Owner: County of Hawaii
Contractor: Nan, Inc. Project No.: WW-4705R
Project Name: Hilo WWTP Phase 1 Submittal Number:
Submittal Title: For Information Only
TO:
From: Nan Inc.

PROJECT: HILO WWTP REHABILITATION
AND REPLACEMENT PROJECT - PHASE 1

JOB NO. WW-4705R

TOP EACH WAY REINFORCEMENT DETAILS
GRIT BASINS - BASE SLAB REINFORCEMENT LAYOUT
SCALE - 1/4"=1'-0"
REF:02-S-01-105

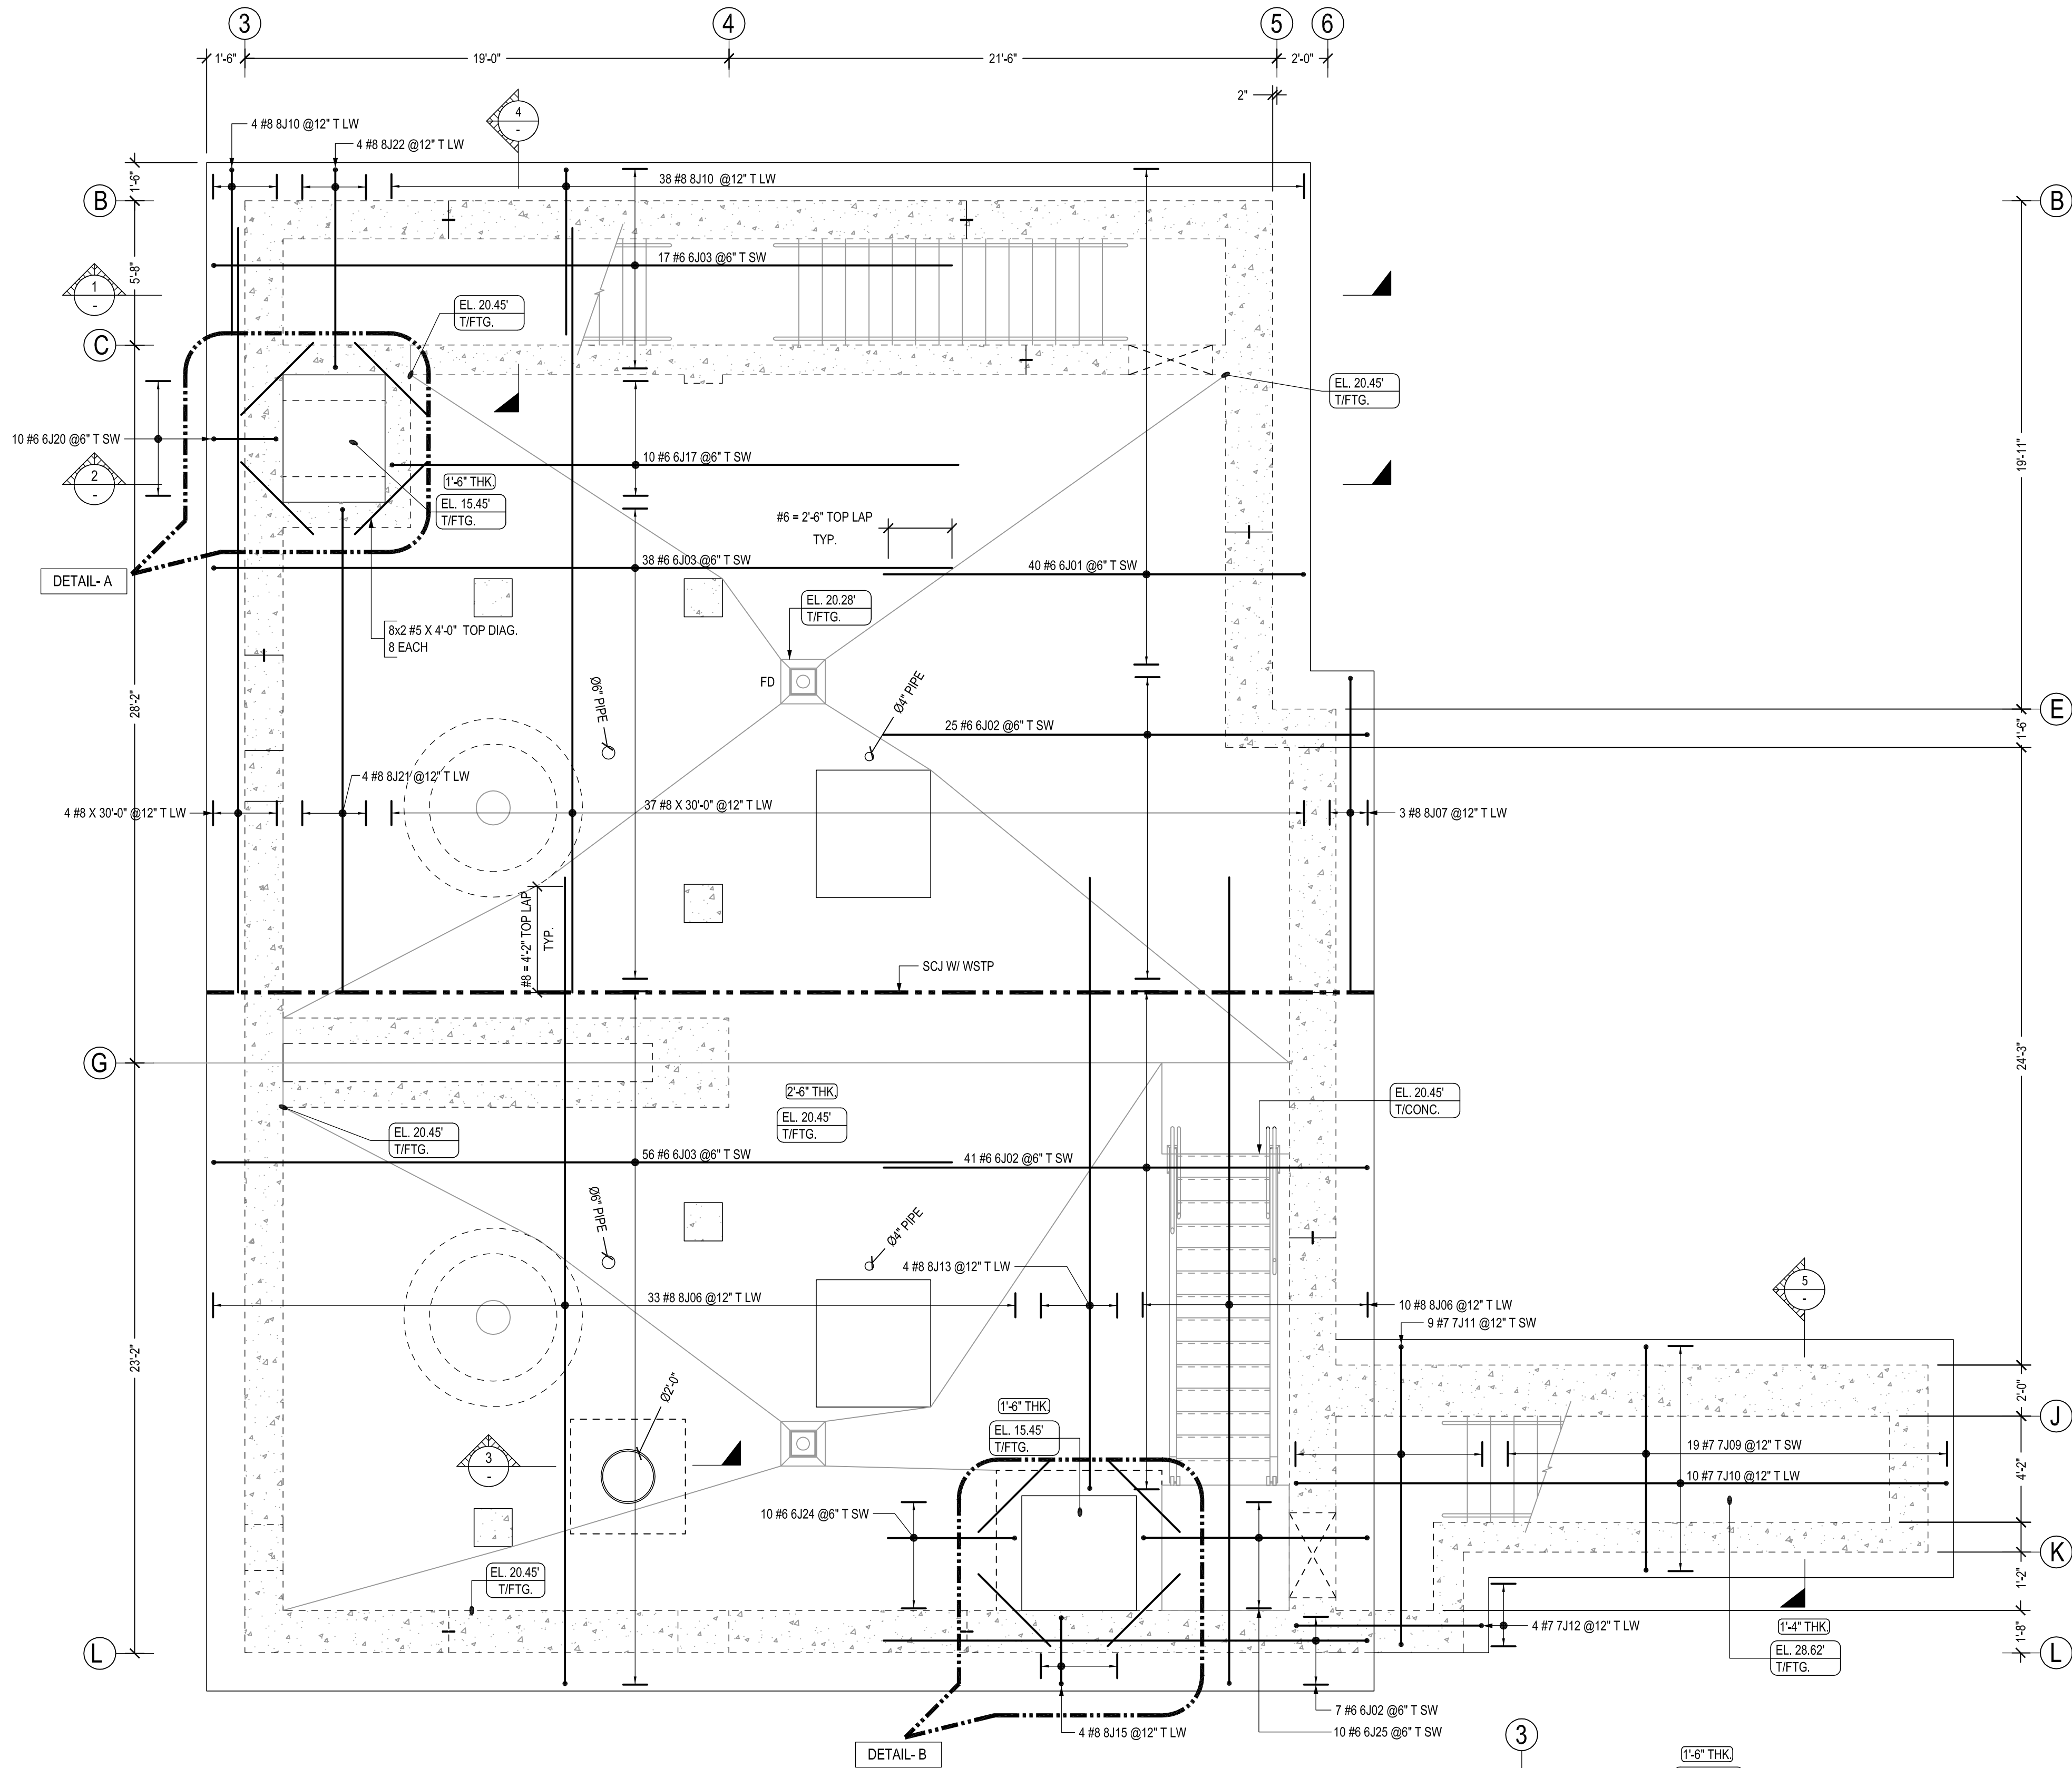
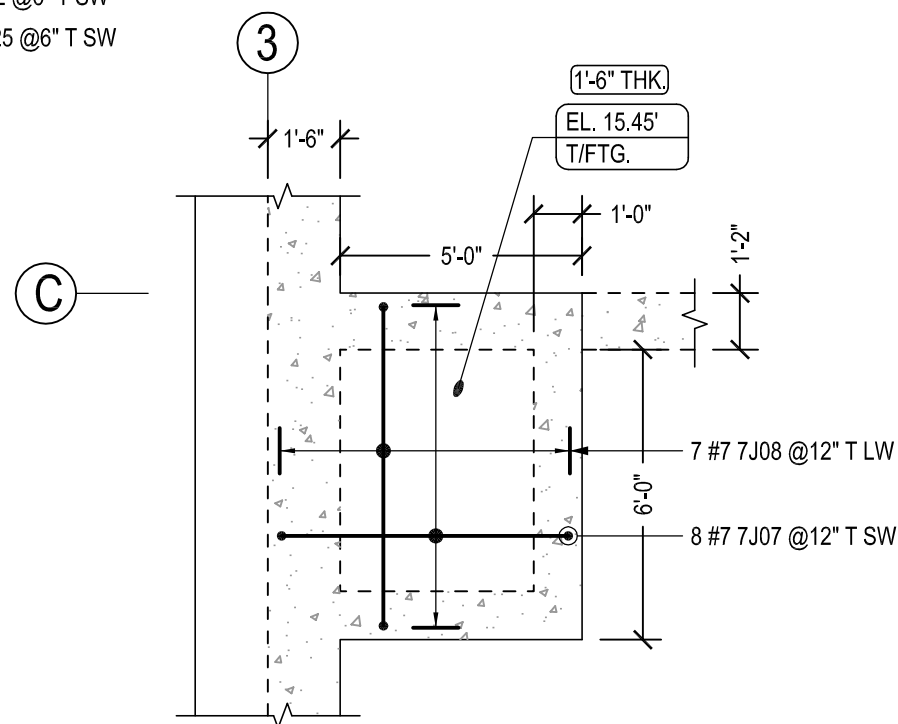
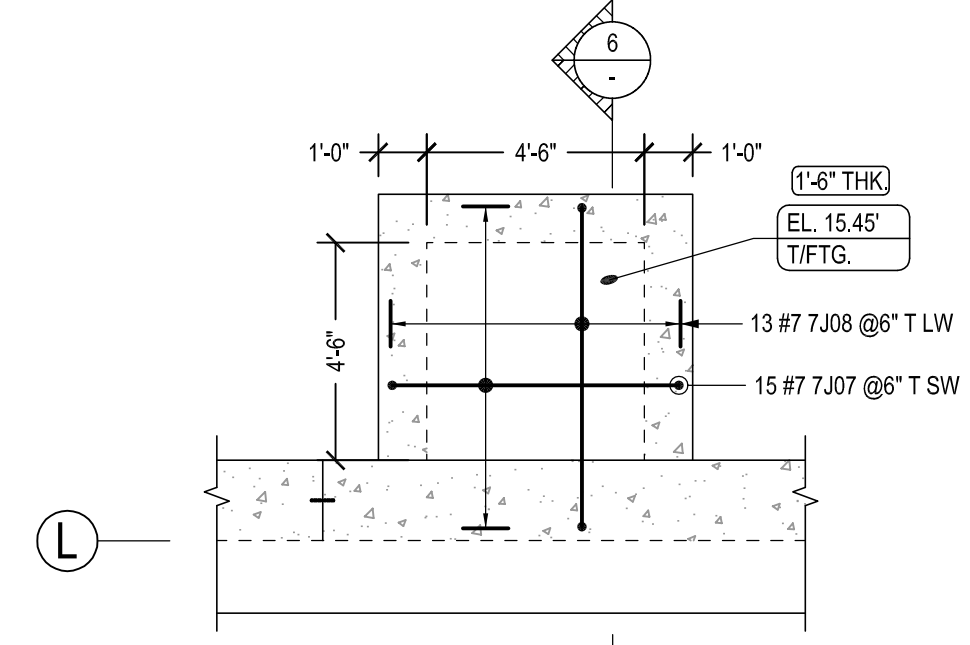
1. Refer to attached PDF for comments. Verify and address all comments.
Incorporated in the attachments.
2. The Contractor shall verify and/or confirm all clouded items, unless otherwise noted.
Incorporated in the attached drawings with clouds.
3. The Contractor shall verify and confirm locations, dimensions, and height of all equipment pads.
Incorporated in the attached drawings with clouds.
4. Refer to Keynote 3 on Drawing 02-S-01-106. The Contractor shall verify and confirm diameter and wall thickness of grit basin tank structures.
Incorporated in the attached drawings with clouds.
5. The Contractor shall verify and coordinate all openings required per the mechanical and electrical drawings and provide additional reinforcement per S144/TYP.
Incorporated in the attached drawings with clouds.

SUBMITTAL RECORD	
DATE	07/03/25
FOR	APPROVAL
DATE	
FOR	
DATE	
FOR	
DATE	09/09/25
FOR	REVISED AS PER A/E COMMENTS
DATE	
FOR	
DATE	
FOR
